**Basement Impact  
Assessment Audit**

25 Oakhill Avenue, London  
NW3 7RD

For  
London Borough of Camden

Project No.  
13693-96

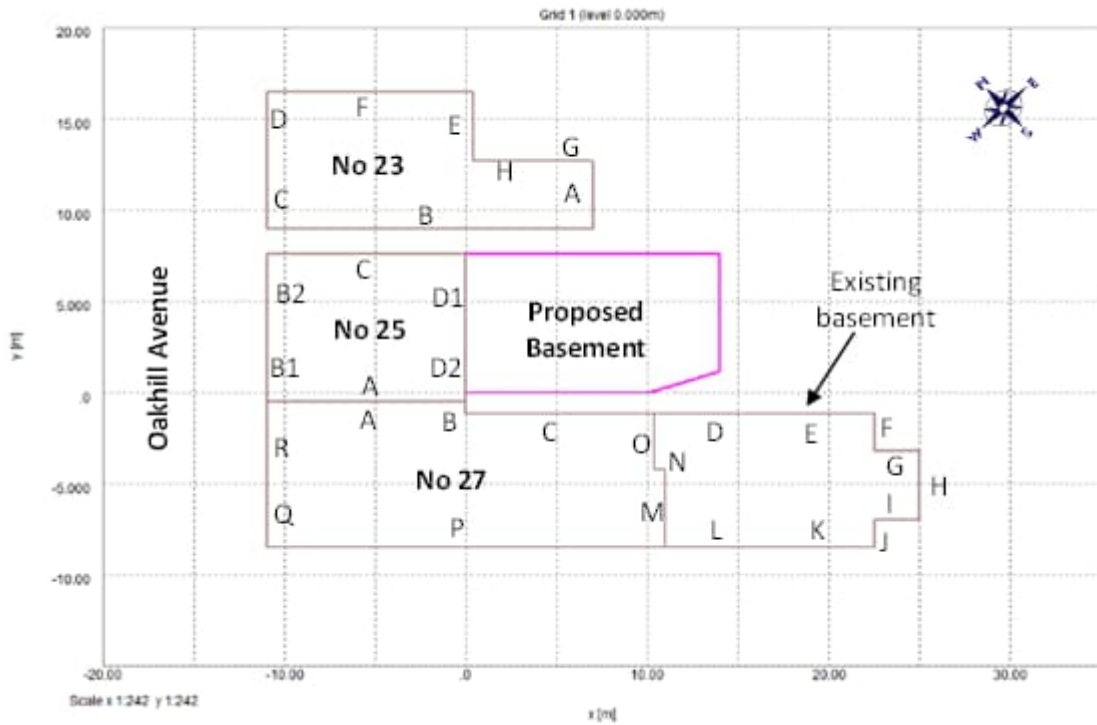
5.6 (see also comments in Section 4.13) – The presence of this area is already highlighted in the response to the relevant screening question in Section 3.1.2 and relates to a small change in level between the gardens of No 17 and 19 Oakhill Avenue and the adjoining property of No 10 Greenaway Gardens. This feature is at a distance in excess of 20 m and is separated from the site by an area of essentially level ground. It is therefore at a distance that it will not be affected by the proposed basement construction and has not been considered further in the report.

Horizontal Displacement Contours: Grid 1 (level 0.000m) Interval 1mm

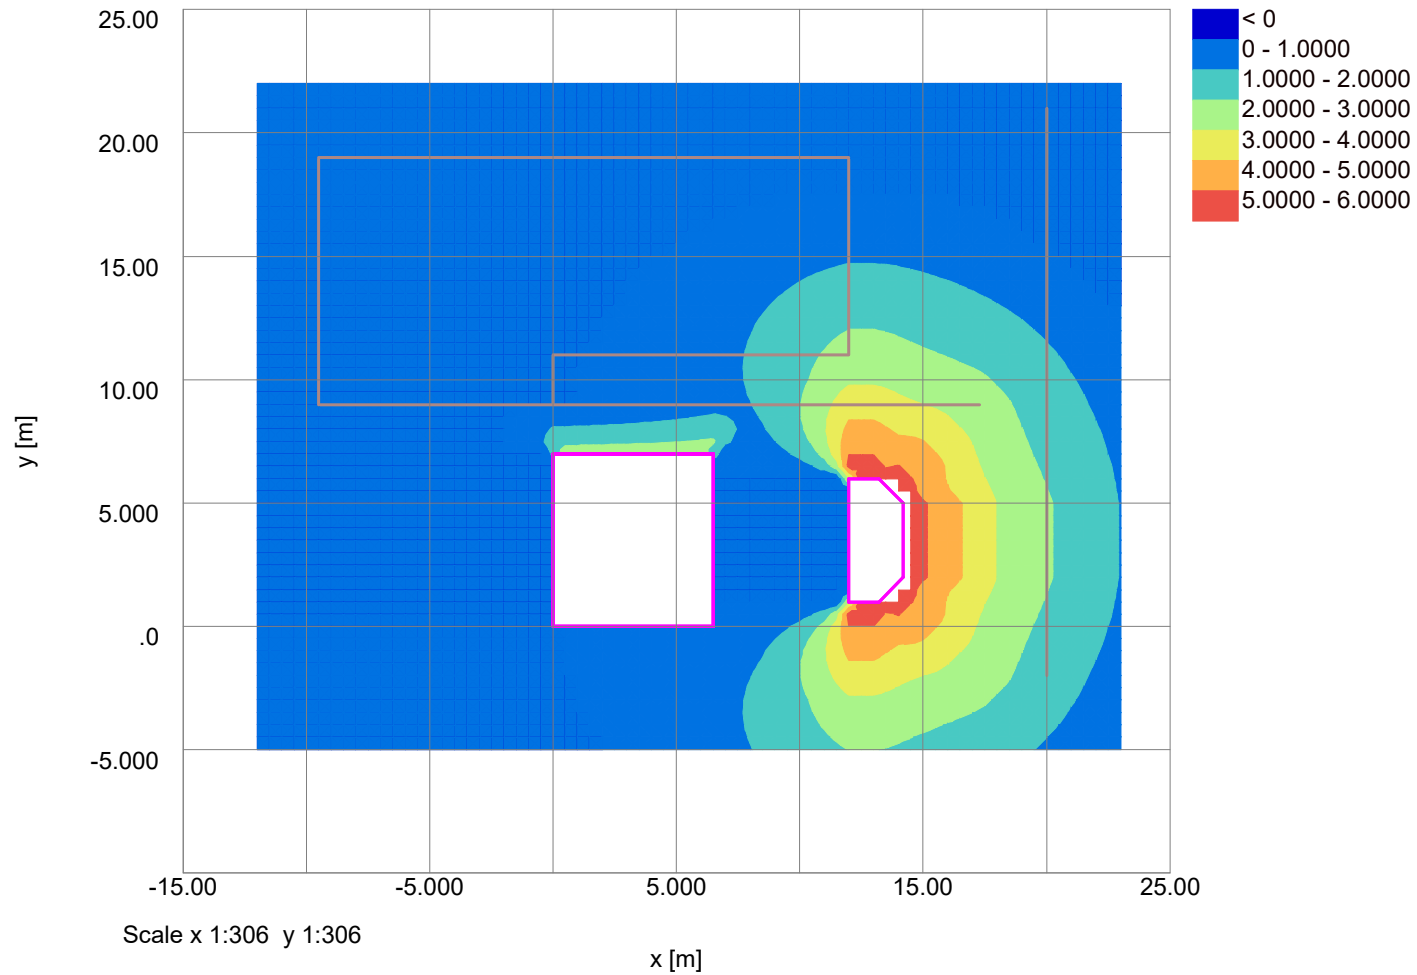
5.9 & 5.10 (see also comments in Section 4.20, 4.22 & 4.23) – A sensitivity analysis has been undertaken with default installation curves, the results of which are attached with the predicted movements summarised in the table below.

Despite the above, we have amended the previous analysis to allow for a higher range of movement (see attached contour plots), which for the proposed lightwell structure has been achieved by amending the vertical movement curve for excavation to produce slightly more movement. For the underpinning proposed as part of the deepening of the existing basement, we have layered additional vertical movement curves over the original model until this has produced the desired amount of vertical movement (equivalent to a movement relationship of 1% of the likely retained height). A similar process has been to the horizontal movements, which have been increased to a maximum of 3 mm (equivalent to a relationship of approx. 0.6% of the likely retained height). We also attach the corresponding damage assessment results, which confirm that the anticipated damage to the nearby structure as a result of these movements remains within tolerable limits. Happy to provide additional input & output data in due course, as required, but trust that the findings of this sensitivity analysis are acceptable and sufficient to close out the relevant query.
